ADDENDUM NO. 1
EAST END ELEMENTARY
SHERIDAN SCHOOL DISTRICT
SHERIDAN, ARKANSAS
Project No. 25053

June 1, 2026

The proposed Contract Documents, dated May 18, 2026, have been modified as follows:

NORTH
1 C1.3 SITE ROOF & CONDENSATE DRAINAGE PLAN
SCALE: 1" = 40'
0 40 80

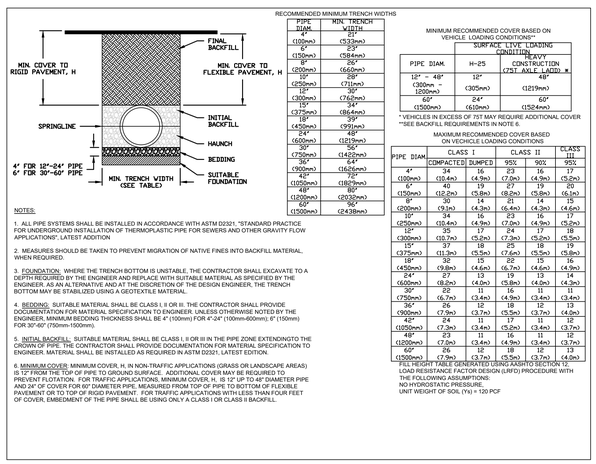
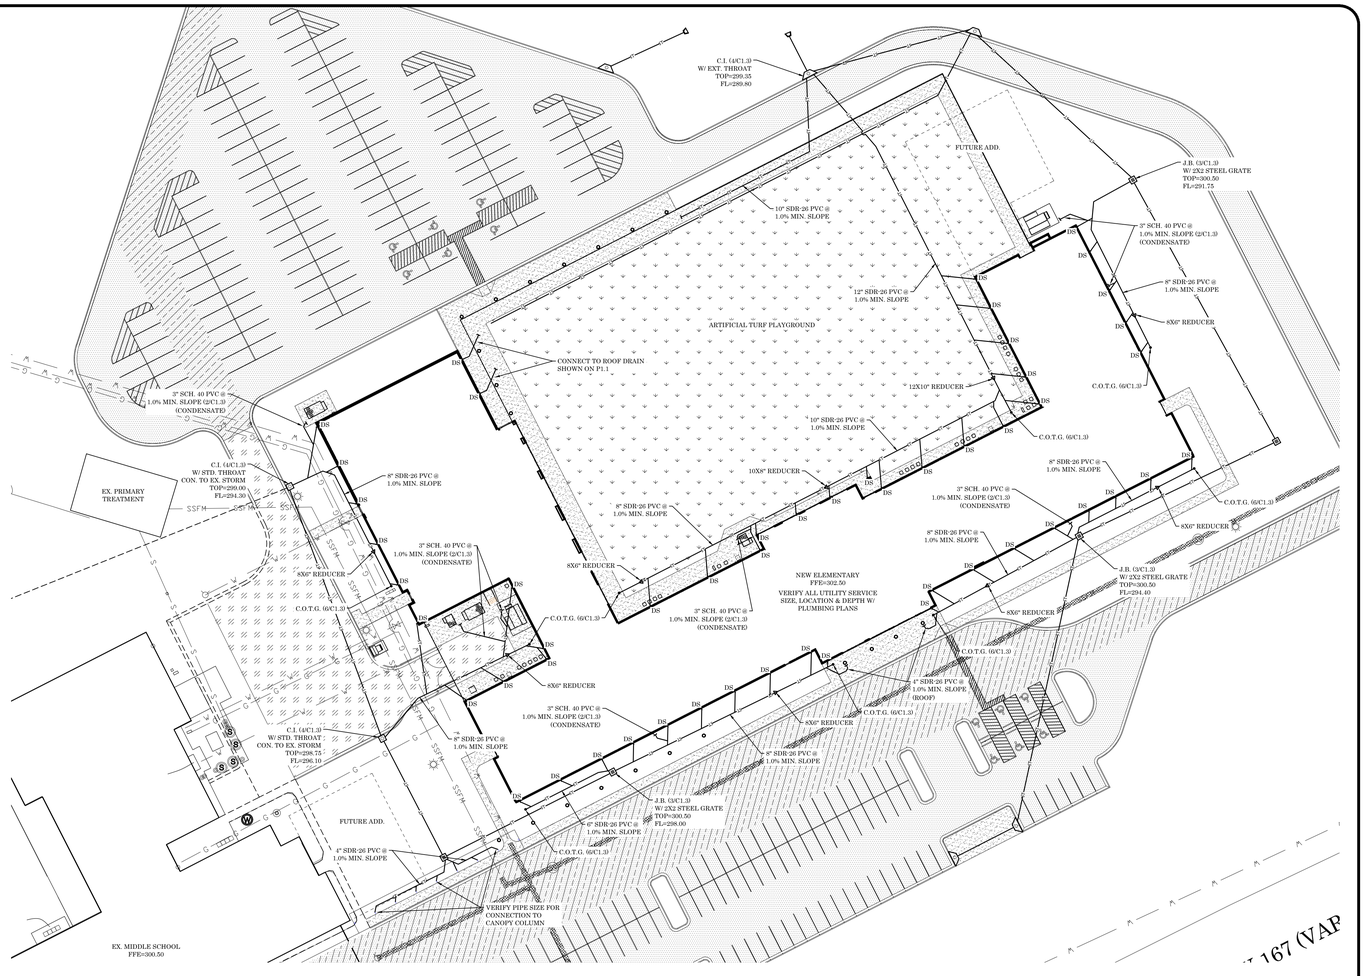
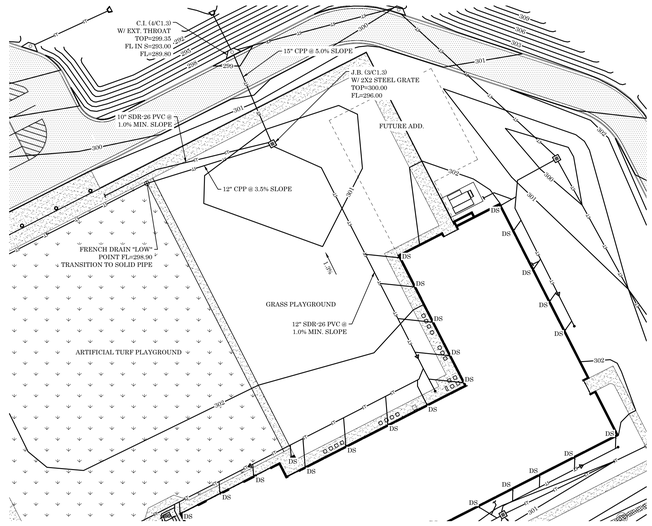
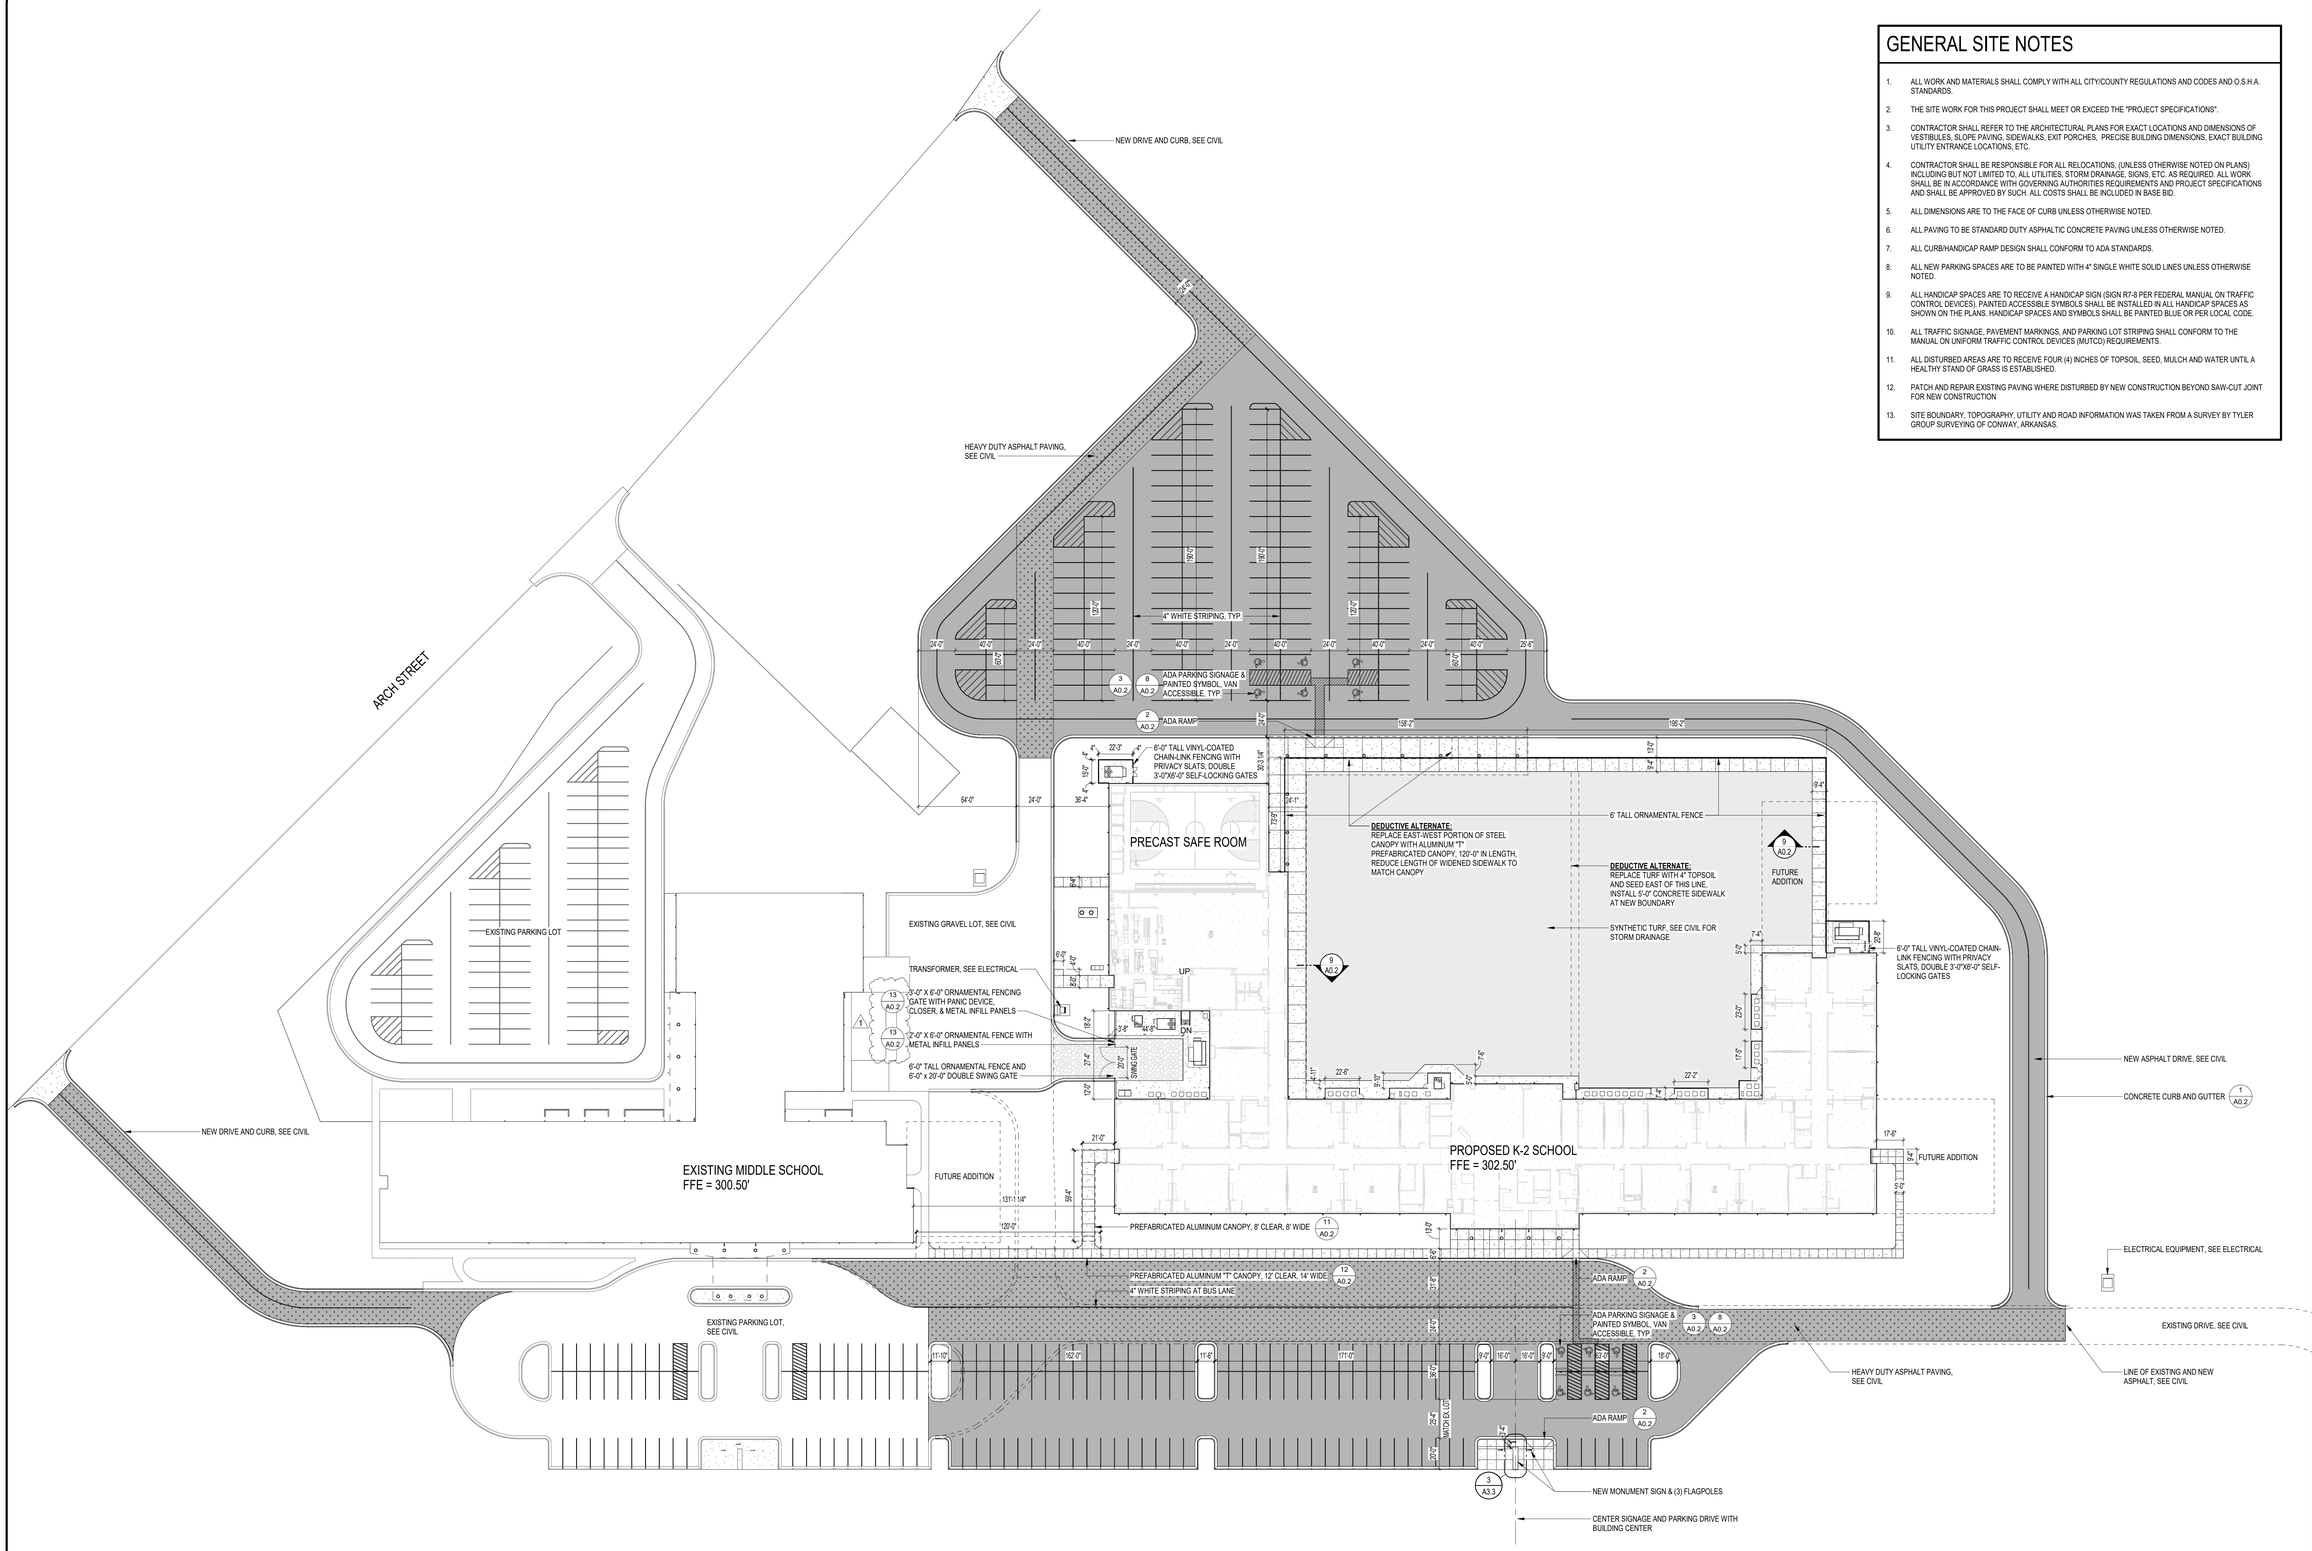
Item #18: Sheet C1.3 - Site Roof & Condensate Drainage Plan: Replace with the attached sheet dated 2026 06-01.

CHANGES IN THIS REVISION:
1) ADDED PLAN FOR TURF PLAYGROUND ALTERNATE (7/C1.3).
